# BULLETIN

NO. H99A-003

### SUBJECT: TECUMSEH POWERED 5000 WATT GENERATOR

### AFFECTS: MODEL LR5000T (UT03829)

#### SUBJECT: PULLEY IMPROVEMENT

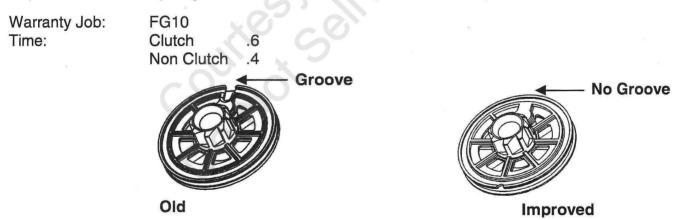
The starter pulley UP03012 on Zip Start<sup>™</sup> Trimmers has been improved to minimize the occurrences of the starter rope being derailed from the pulley. The groove on the face of the pulley has been filled in so it cannot catch the rope and cause it not to rewind in the pulley. The part number of the pulley has not changed but you can visually identify the improved pulley as shown below. Replacements of this pulley are covered by warranty. See Warranty Codes below.

Check your stock of pulley UP03012, any old style pulley should be returned to JDCP. To return, fill out a warranty claim and under **Model No** show "**Part**" and in **Conditions Found** show "**Defective Part from Stock**". You will be reimbursed net for the part, no labor is allowed.
